Exhibit A
File No. 241464
1st Amendment to Detailed Planned Development
Holy Cathedral Church of God in Christ (aka Cathedral Heights)
7200 W. Florist Avenue
February 19, 2025

This 1st Amendment to the DPD will allow changes to the previously approved plans for the construction of a church as follows:

A NEW FACILITY FOR
HOLY CATHEDRAL CHURCH OF GOD IN CHRIST
MILWAUKEE, WISCONSIN

ELEVATIONS

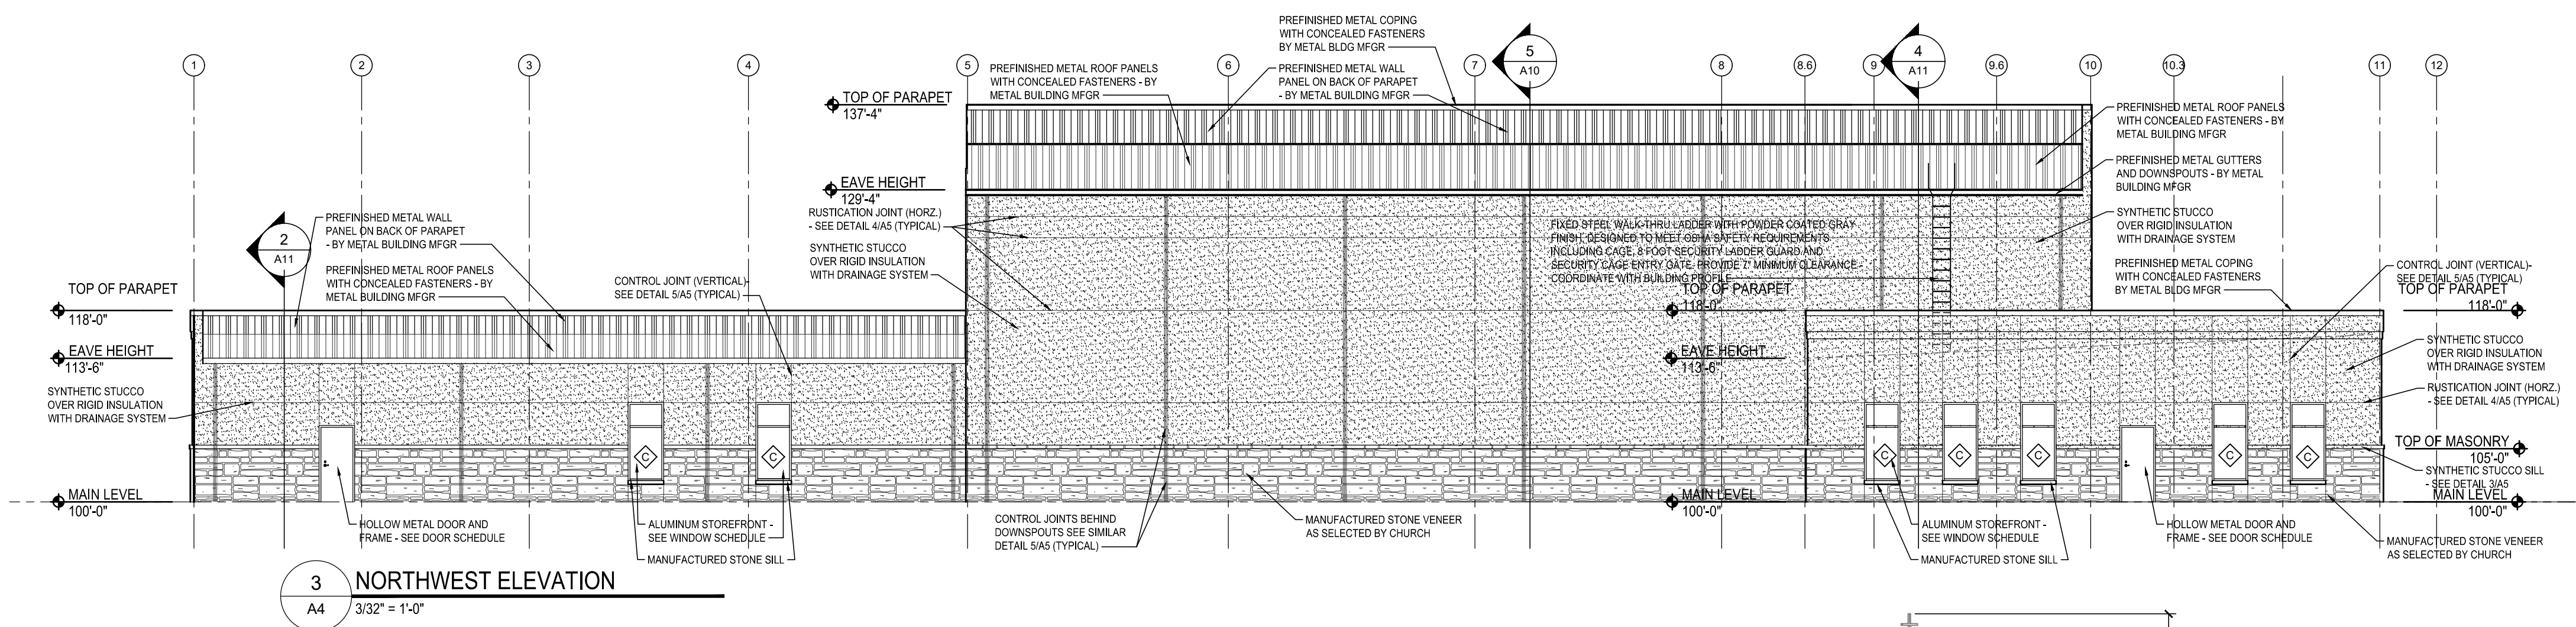
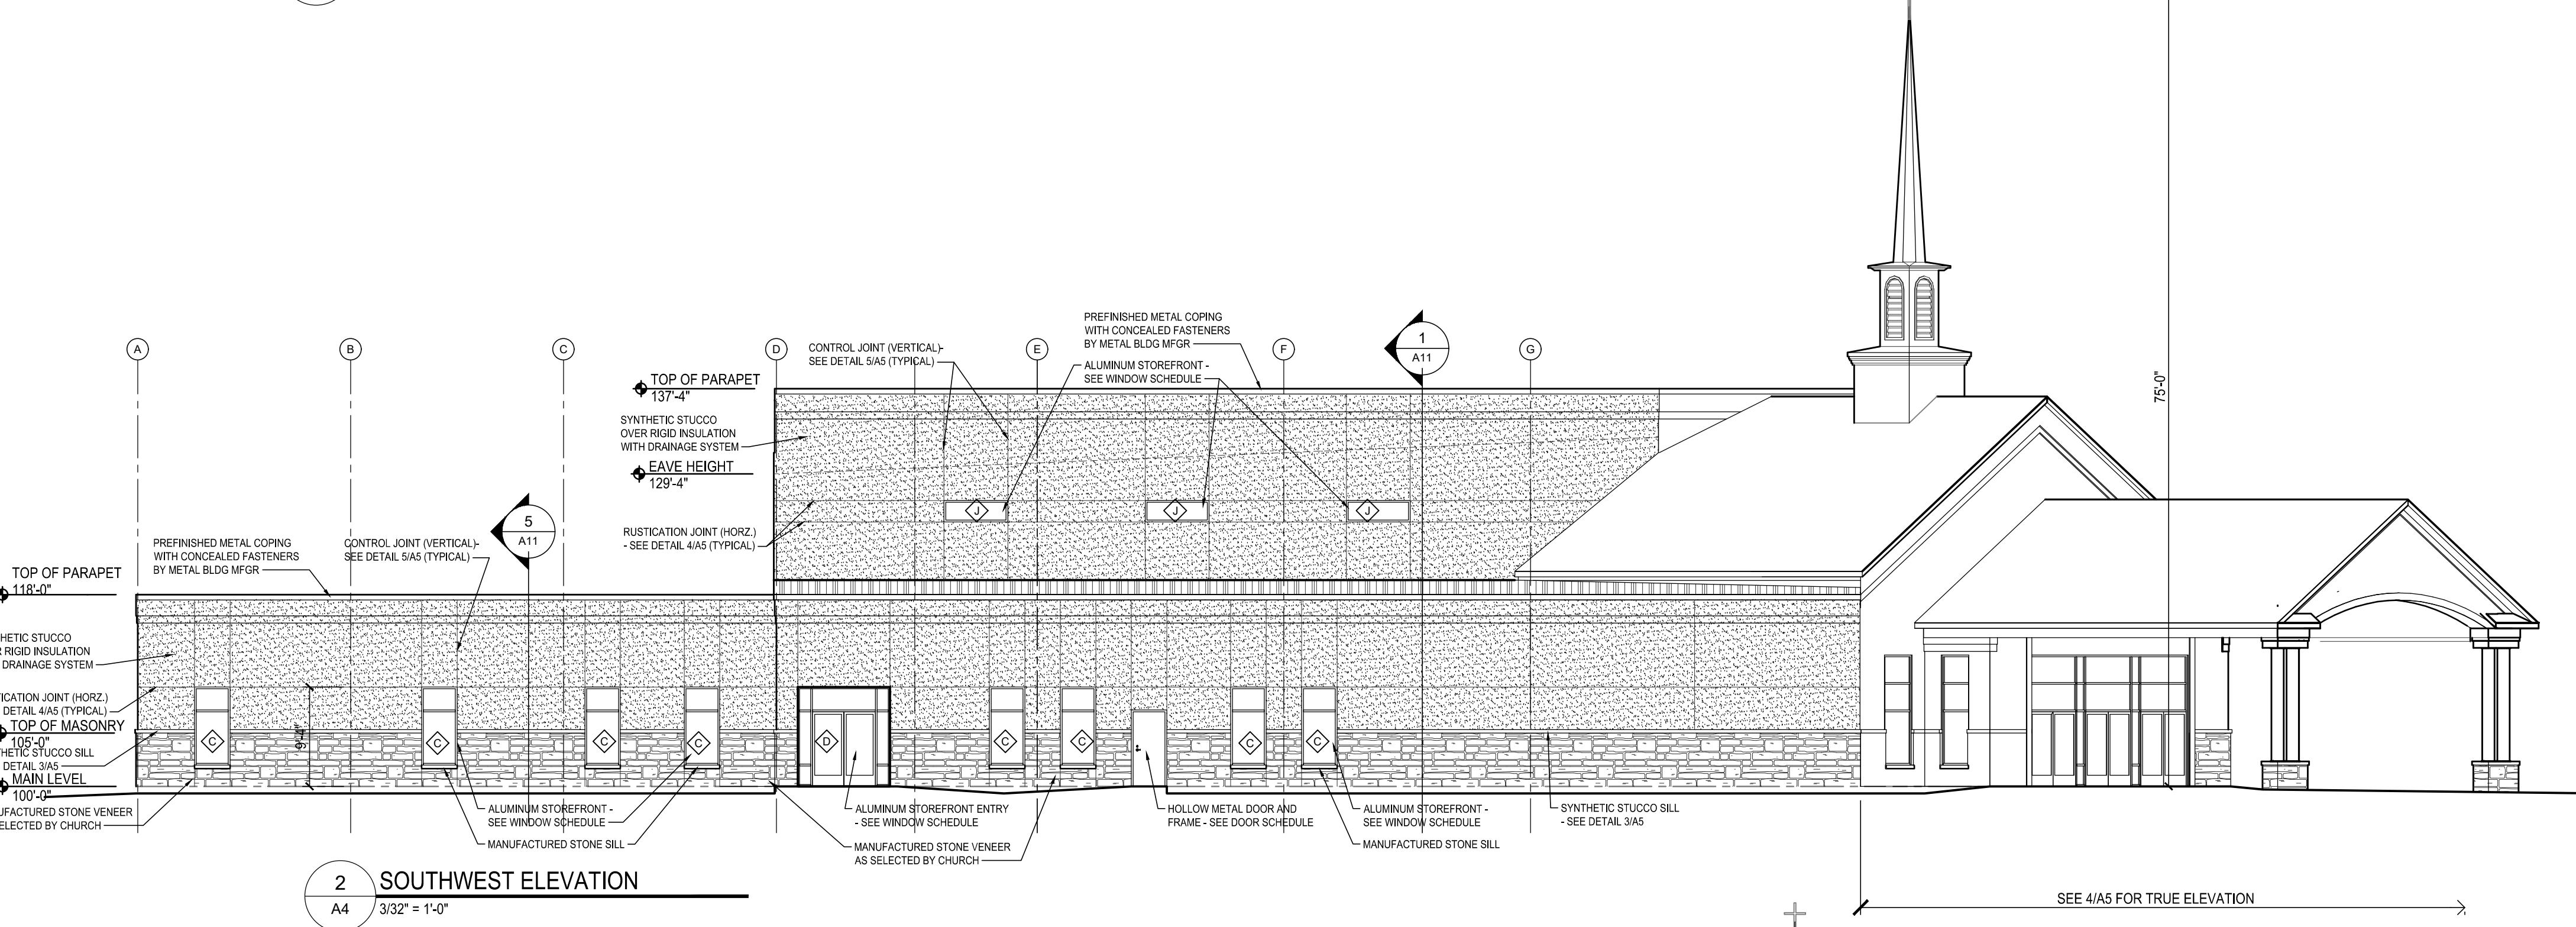
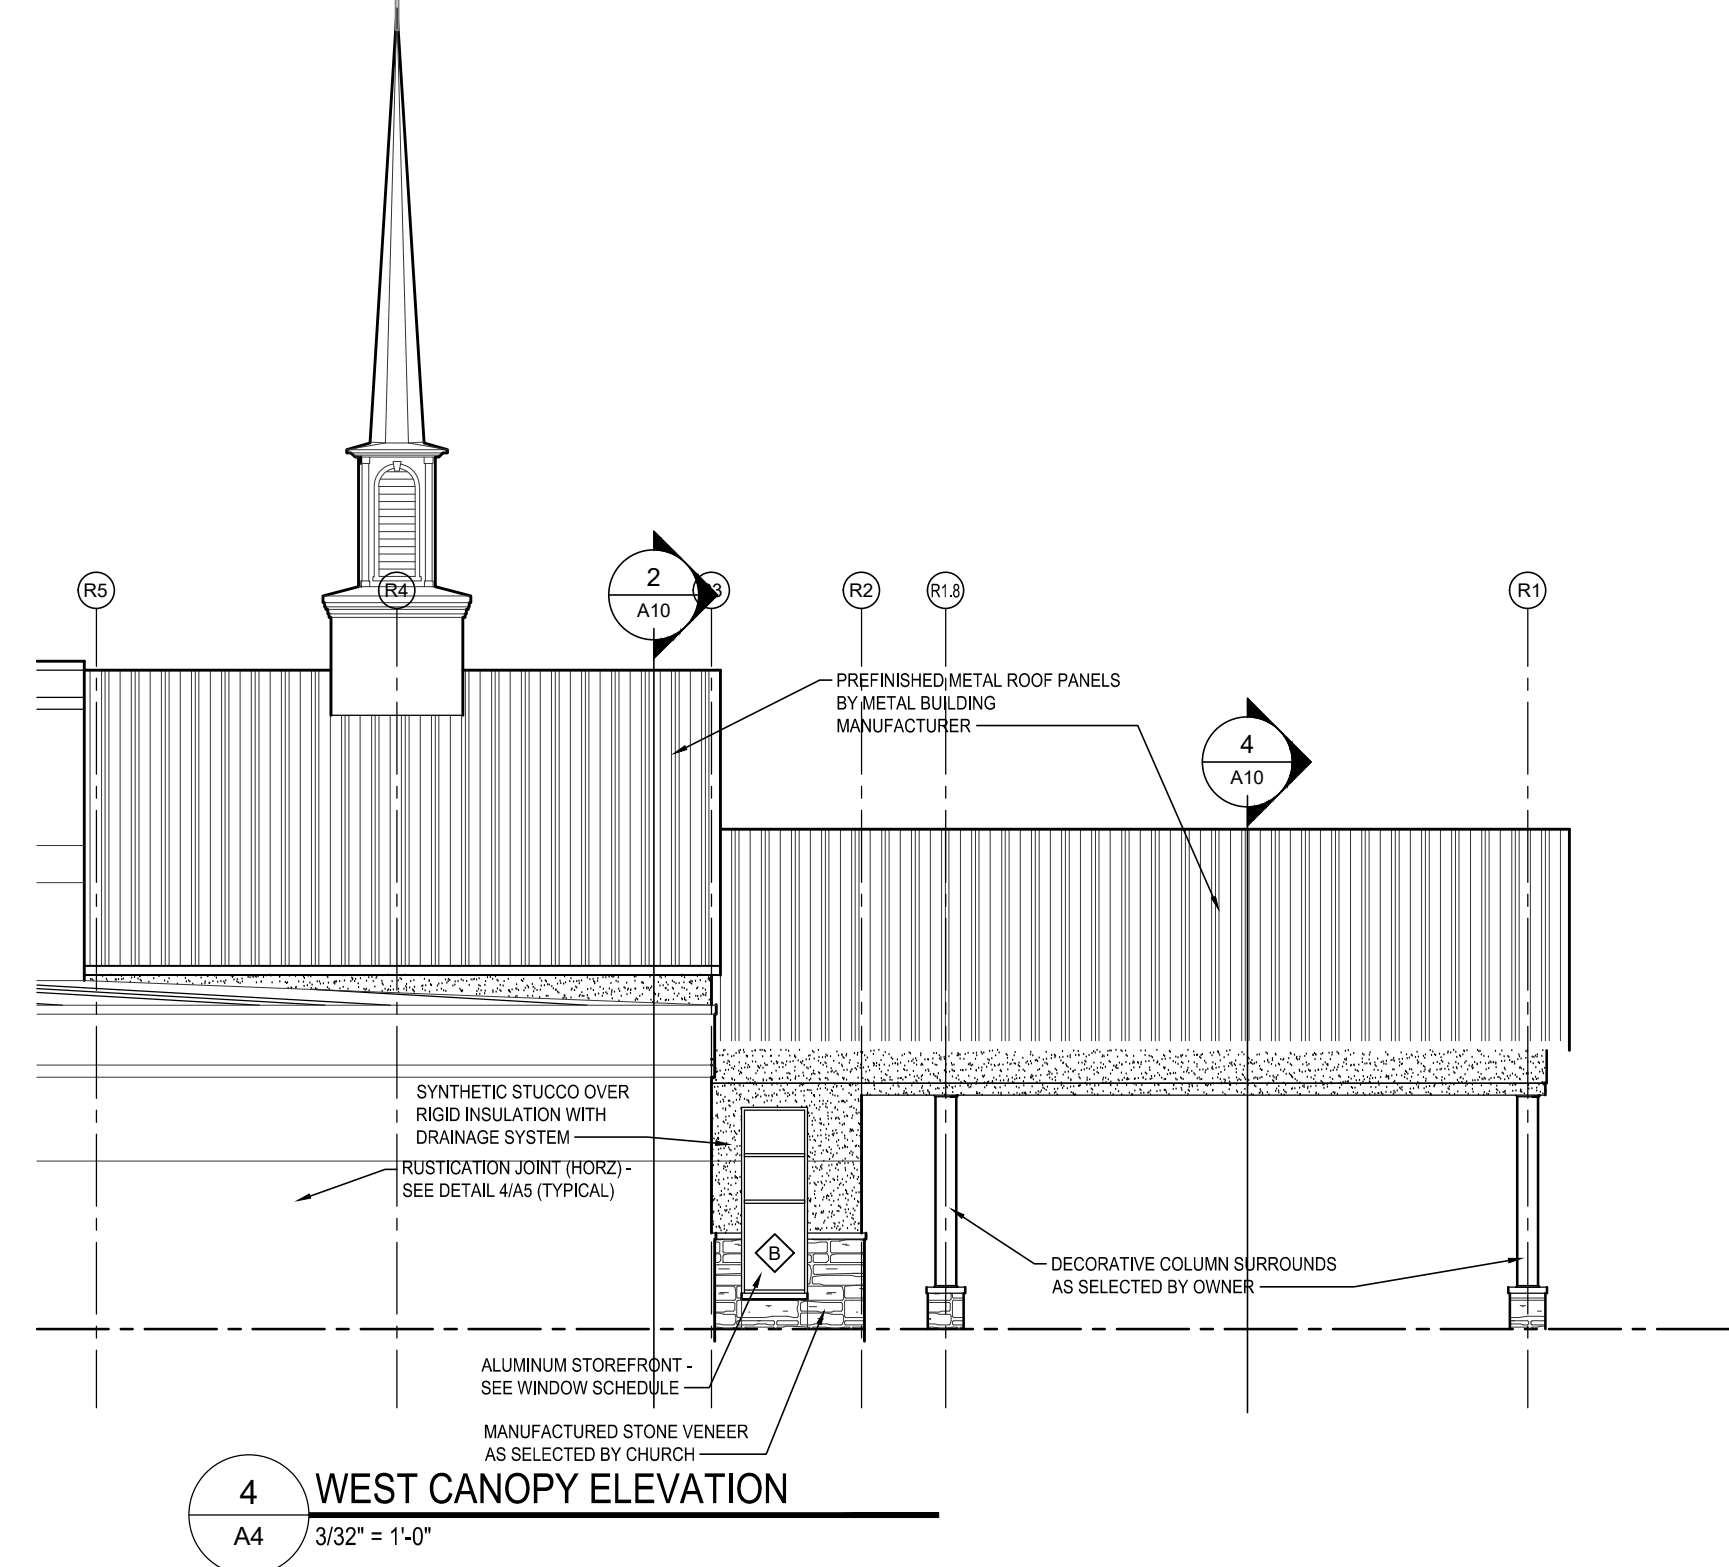
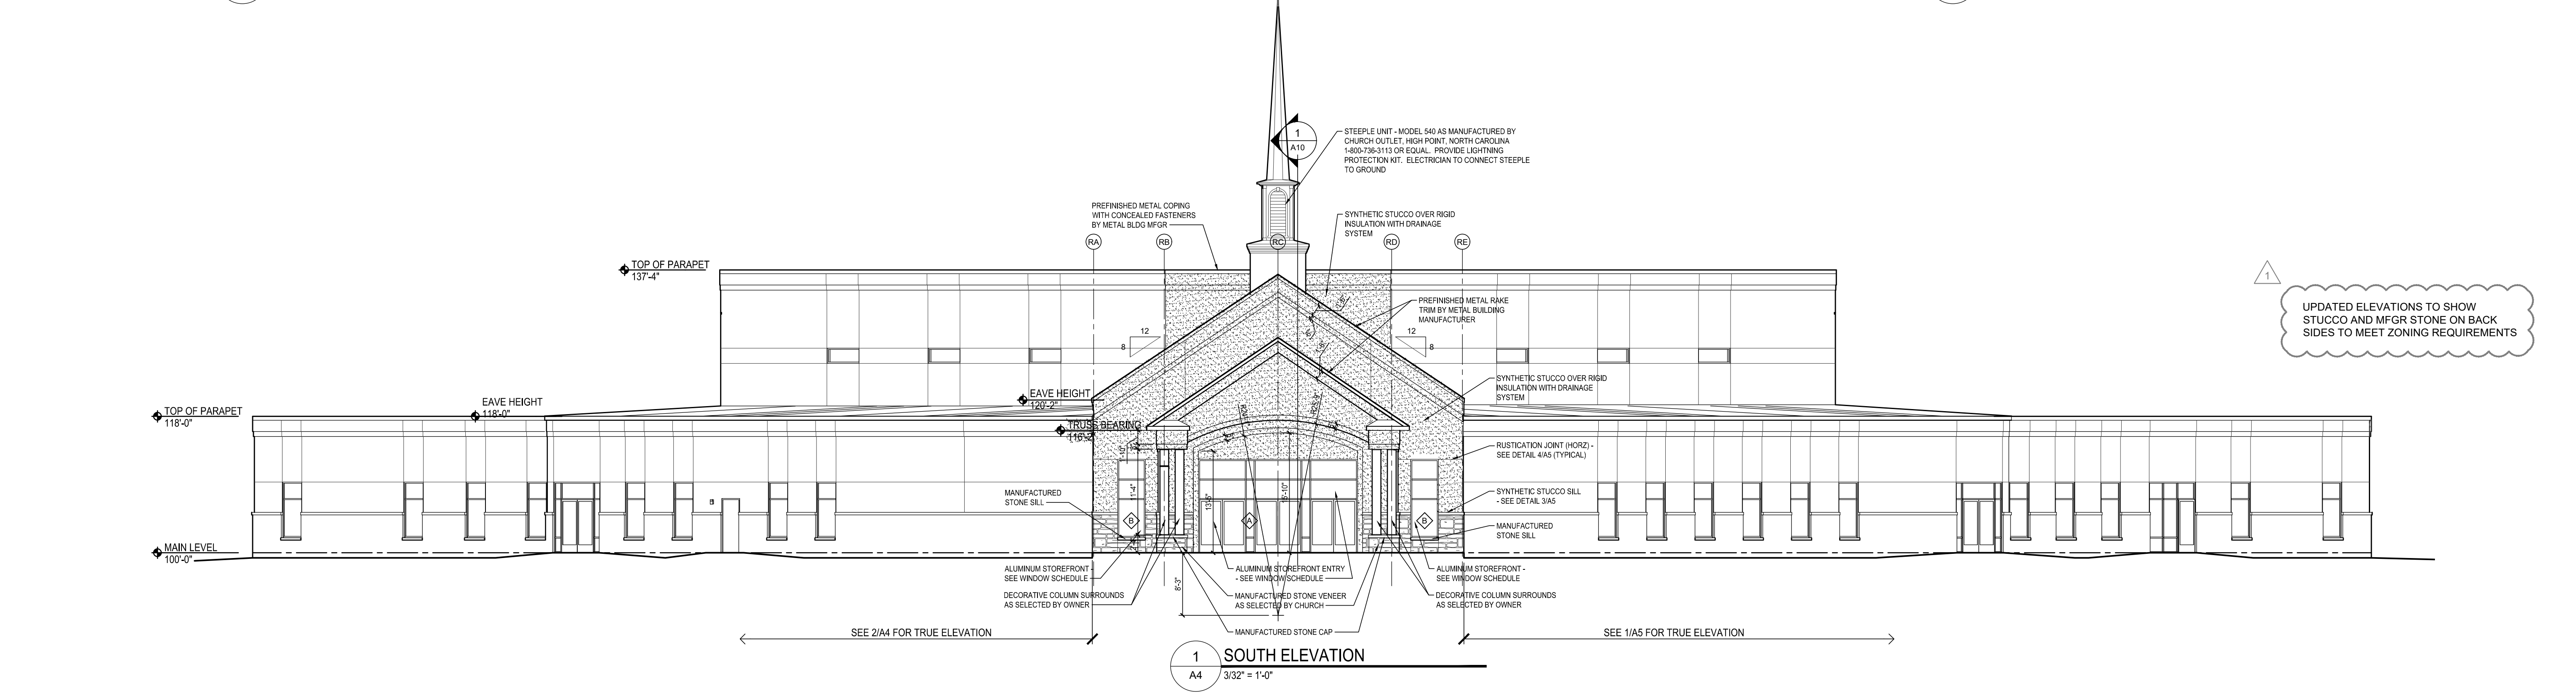
UPDATED ELEVATIONS TO SHOW STUCCO AND MFRG STONE ON BACK SIDES TO MEET ZONING REQUIREMENTS
